Form A – IGG Design Discussion Request

Discussion Request Number	Title	Priority
DR 0151	Amending Generator Unit ID and Generation Unit ID	<i>High</i>

This DR is intended to redefine the message field 'Generation Unit ID' as a container and to correct the incorrect references to Generator Unit ID in the supporting information. This will be included in version 6.1 of ARIS. Version 6.1 of the schema is correct and does not require change. This DR also seeks agreement to correcting incidental references in MCRs to 'Generator Unit ID' where these are incorrect.

MM 594

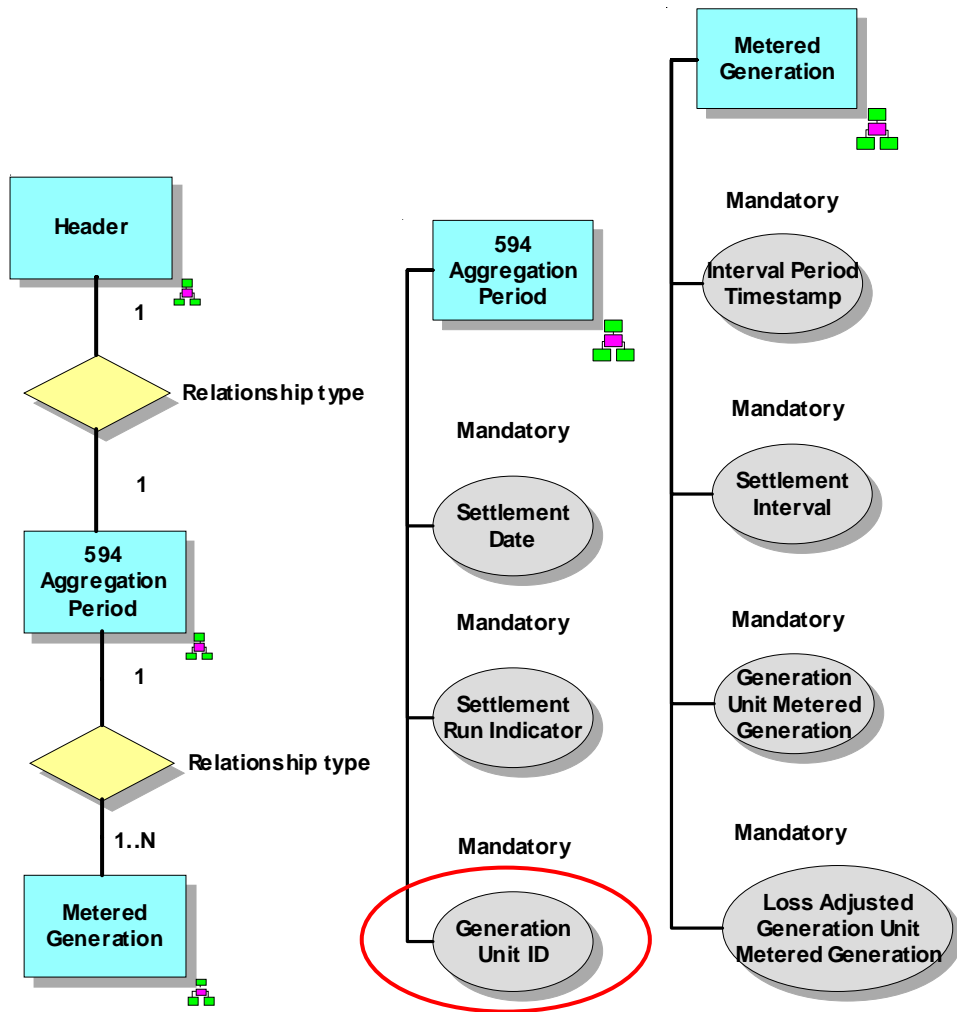
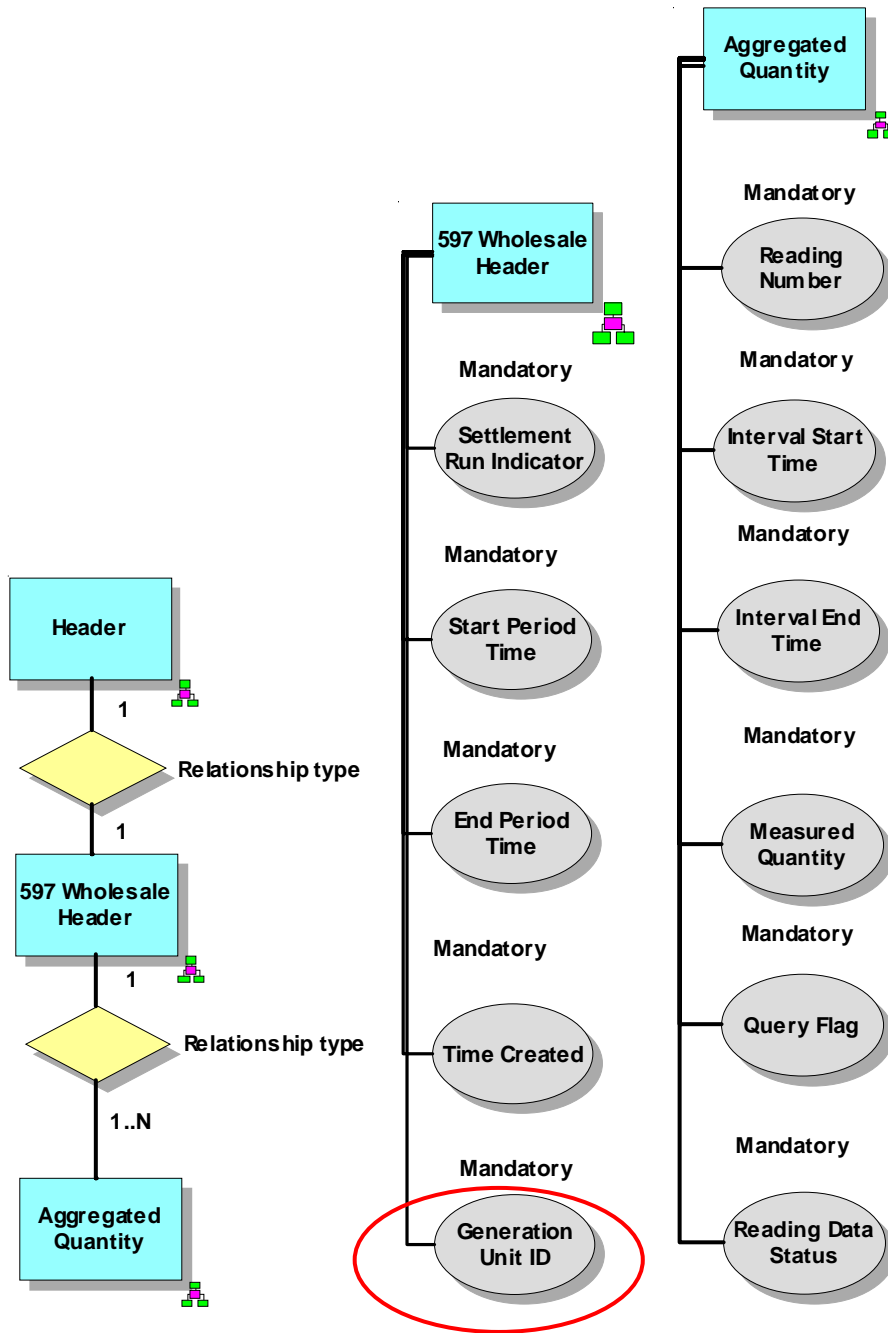
Note: Details of new Data Items and Definitions (~~i.e. Supplier Unit ID, Generator Unit ID~~) can be
